Subject: UniStar Nuclear Energy, NRC Docket No. 52-016  
Response to Request for Additional Information for the  
Calvert Cliffs Nuclear Power Plant, Unit 3,  
RAI 396, Seismic System Analysis

**Response to NRC Request for Additional Information  
RAI 396, Questions 03.07.02-76 and 03.07.02-77,  
Seismic Design Parameters,  
Calvert Cliffs Nuclear Power Plant, Unit 3**

**RAI No. 396**

FIGURE 1  
SELECTED POINTS FOR THE CALCULATION OF THE BASEMAT ISRS (DIMENSIONS IN FEET)

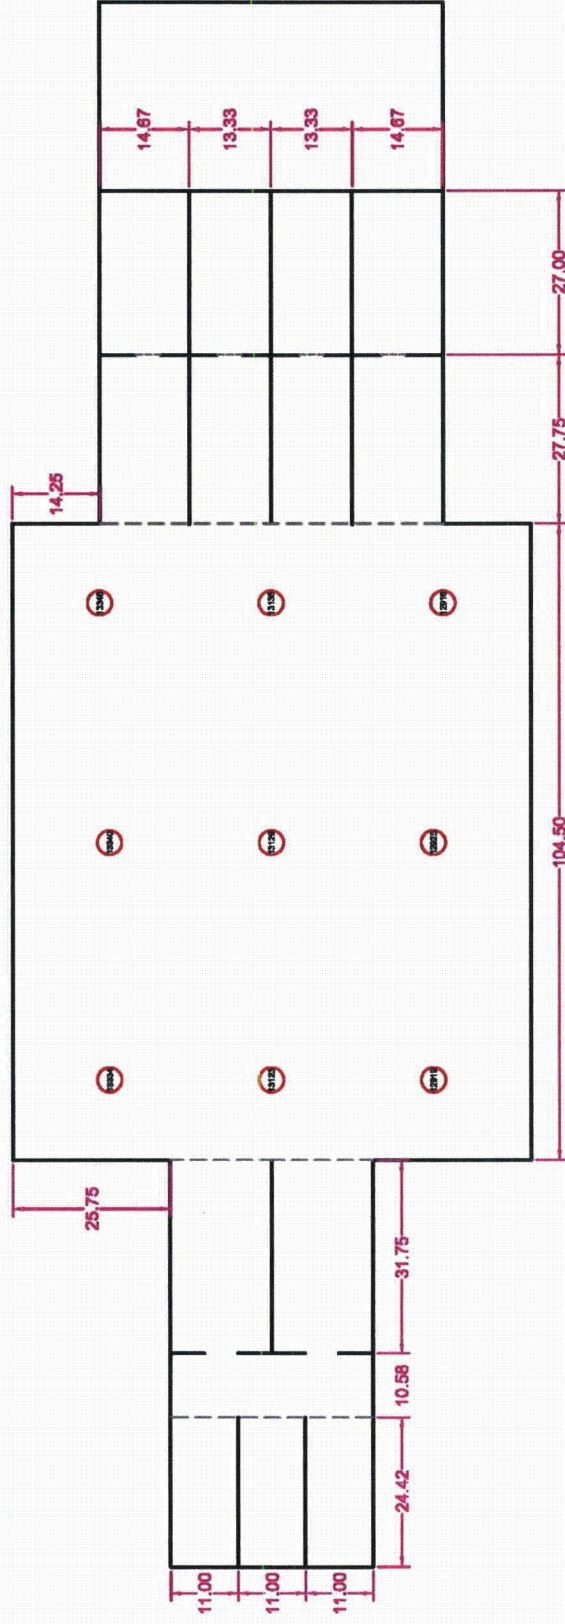
In part 7 of its response the applicant provided information regarding the basis for the calculation of the sloshing effect of the enclosed water within the basins of the CBIS. To calculate the wave height, the applicant has used the equations of ACI 350.3-06 and a water height of 26.84 feet. This water depth was based on a maximum water level of 3.67 ft. above mean sea level. However, based on information in FSAR Section 2.4.5.2.2.1 the maximum water level is 4.4 ft. NGVD. As the normal mean sea level is at 0.64 ft. NGVD, the maximum water level becomes 3.76 ft. above mean seal level not 3.67 ft. This results in a maximum depth of water equal to 26.93 ft. The applicant states that the result of the sloshing is a calculated wave height of 0.95 ft. in the forebay and a remaining freeboard of 9.05 ft. According to Figure 2 of the response the height of the forebay wall is 32.50 ft. Subtracting a water height of 26.93 ft. and a calculated wave height of 0.95 ft. the remaining freeboard is 4.62 ft. not the 9.05 ft. reported in the response. The applicant is requested to address these discrepancies identified in its response.

In selecting the spectral response to be used in determining the wave height, the applicant stated that it used as input the site-specific Foundation Input Response Spectra (FIRS). However, the seismic analysis of the CBIS is based on the site SSE not the FIRS. In addition, the staff believes the basemat ISRS should be used to calculate the wave height and not the spectra in the free field. The applicant is requested to provide the technical basis for its response and why the CBIS foundation basemat ISRS was not used to determine the sloshing effect of enclosed water. In addition the applicant is requested to explain why the higher water level of 4.4 ft. NGVD 29 was not used as the basis for determining the impulsive and convective water masses for the CBIS analysis since this higher water level is based on an anticipated increase over time of the water level in the Chesapeake Bay as documented in FSAR Section 2.4.5.2.2.1.

Using the maximum water height of 26.84 ft, instead of the mean height, the sloshing height is recalculated using the results from the SSI analysis of the CBIS. The basemat ISRS are used to calculate the maximum height of sloshing in the forebay. For this purpose, the CBIS model with the SSE motion and best estimate (BE) soil condition is used. Figure 1 shows the CBIS basemat and the location of the selected nodes in the forebay for the calculation of the basemat ISRS in N-S (X) and E-W (Y) directions.

The calculation of the basemat ISRS, for one particular direction, is in accordance with the following process:

1. Response accelerations are calculated at the selected nodes in the basemat, in a particular direction, as the algebraic summation of the acceleration time histories in that direction due to input motions in N-S (X), E-W (Y) and Vertical (Z) directions.

2. Response accelerations in a particular direction, due to input motions in X, Y and Z directions, are used to calculate response spectra for each selected node for 0.5% of critical damping.
3. Response spectra in a particular direction are enveloped, widened and smoothed to obtain the basemat ISRS in that direction. A widening factor of 0.15 is used for the frequency of each peak, as stated in U.S. NRC R.G. 1.122.

The maximum sloshing height ( $d_{max}$ ) in the forebay is calculated for N-S (X) and E-W (Y) directions, using equation 1 (ACI 350.3-06):

$$d_{max} = \frac{L}{2} C_c I \quad (\text{Equation 1})$$

The seismic response coefficient,  $C_c$ , is given by 2/3 of the maximum spectral acceleration calculated from the basemat ISRS and for the natural period of the first convective mode of sloshing. The term " $I$ " is the Importance Factor.

Based on the above, the maximum height of sloshing is calculated as 3.45 ft. The results are presented in Table 1. The freeboard of the forebay is obtained by subtracting the maximum water depth (26.84 ft) and the calculated maximum sloshing wave depth of 3.45 ft from the height of the forebay wall (32.5 ft). The resulting freeboard is 2.24 ft. Therefore, the tank top head is adequate.

FIGURE 1: DESIGN RESPONSE SPECTRA (5% SSE, 3% SSE, 0.5% SSE, and 0.5% AWWA)

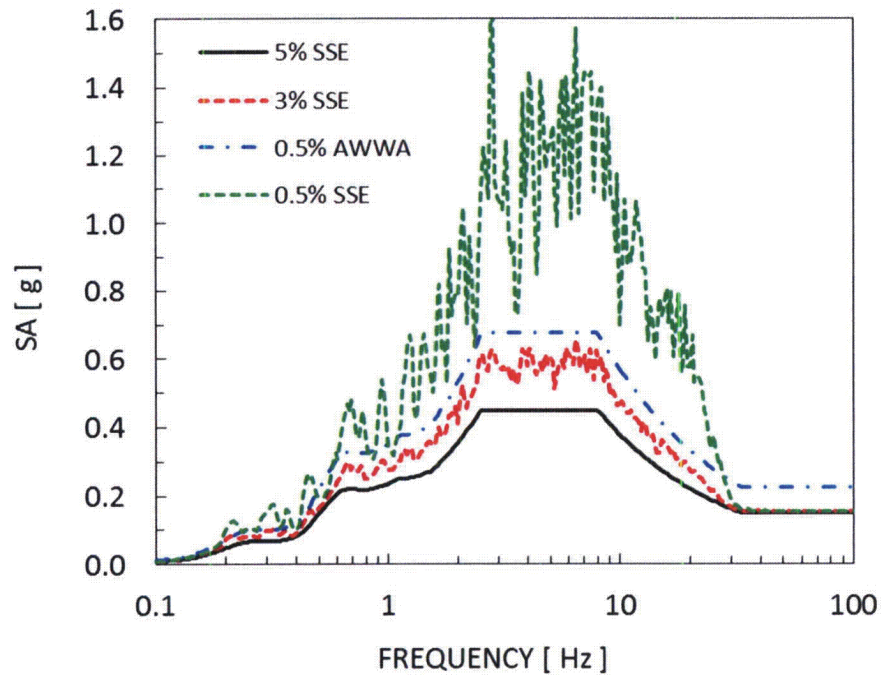
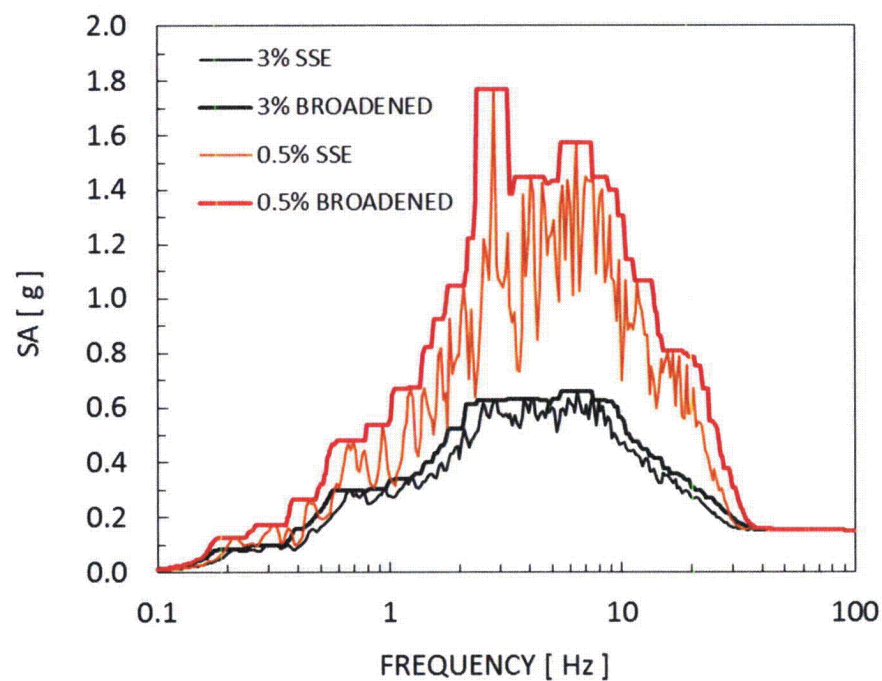
The applicant states that to determine the acceleration of the impulsive component of the water, the maximum spectral acceleration (0.45g) of the SSE will be used. The applicant is requested to confirm that the damping value to be used for the FWSTs complies with R.G. 1.61 for metal atmospheric storage tanks, i.e. 3 percent for the impulsive component and 0.5 percent for the sloshing component, or provide justification for not doing so. The applicant is also requested to provide the design response spectra for both of these damping values and state how the forces on the tank associated with sloshing component are determined.

For the FWSTs, as requested, Figure 1 provides the 0.5% and 3% damping response spectra. For comparison purposes, the 0.5% damping spectra include the AWWA criteria of 1.5 times the 5% damping (Figure 1a). Figure 1b shows the design response spectra for 3% and 0.5% damping consistent with the SSE.

- The impulsive acceleration will be determined from the 3% damping broadened SSE curve, using the AWWA equations with a ductility factor ( $R_i$ ) of 1.0 and importance factor ( $I_E$ ) of 1.5;

- The convective acceleration will be determined from the 0.5% damping broadened SSE curve, using the AWWA equations with a ductility factor ( $R_c$ ) of 1.0 and importance factor ( $I_E$ ) of 1.5; since the AWWA criteria results in lower demand than the broadened SSE, the AWWA criteria used to calculate the 0.5% damping spectra of 1.5 times the 5% damping SSE will not be used for the calculation of the 0.5% response spectra;

TABLE 1: COMPARISON BETWEEN AWWA D-100 and TID-7024  
(Page 1 of 6)

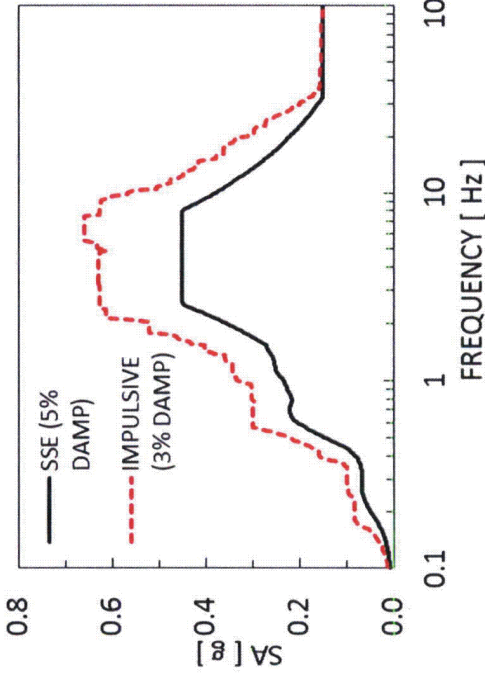
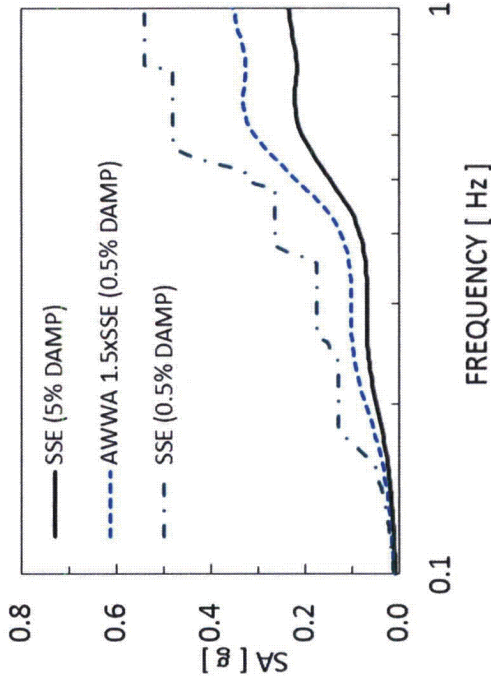
For the FWSTs, the applicant states that the seismic forces will be based on the American Water Works Association (AWWA) D-100 Standard and TID 7024. The applicant is requested to describe any differences between the two standards as they relate to the seismic analysis for the FWSTs. Where they are different, the applicant should explain which of the two documents will be used and the technical basis for this selection. The applicant is also requested to confirm that of SRP 3.7.3 Acceptance Criteria (AC) 14 is being met for the analysis and design of these tanks, or provide justification for not doing so. The applicant should also identify the basis of the assumed water height within the tanks.

In order to point out the differences between AWWA and TID and to establish the criteria that will be used for the design of the FWSTs, a hypothetical example analysis, using a tank diameter of 40 ft and a water height of 35 ft is provided in Table 1.

Differences between AWWA and TID are:

- TID 7024 assumes the tank is rigid, while AWWA D-100 considers both flexible and rigid tank models,
- TID 7024 combines the impulsive and convective forces using absolute sum, while AWWA D-100 combines the impulsive and convective forces using the SRSS (square root of sum of square).
- TID 7024 applies to circular and rectangular tanks. AWWA D-100 applies only to circular welded steel tanks.
- AWWA D-100 incorporates a response modification factor,  $R_i$  (impulsive) and  $R_c$  (convective), in determining horizontal design accelerations.
- AWWA D-100 considers a ground motion design factor ( $U$ ) and the seismic importance factor ( $I_E$ ). Note the importance factor depends on the utility of the tank and the damage consequences.

As previously stated in the response to RAI 378, Question 03.07.02-75<sup>4</sup>, a bounding approach will be considered for the design of tanks. As shown in Table 1, the AWWA methodology is more conservative for the calculation of forces. The design of the tanks will use a 3% damping and 0.5% damping broadened spectra as shown in Line Items 2 and 3 of Table 1. With the AWWA approach, a flexible component of the impulsive mode is included
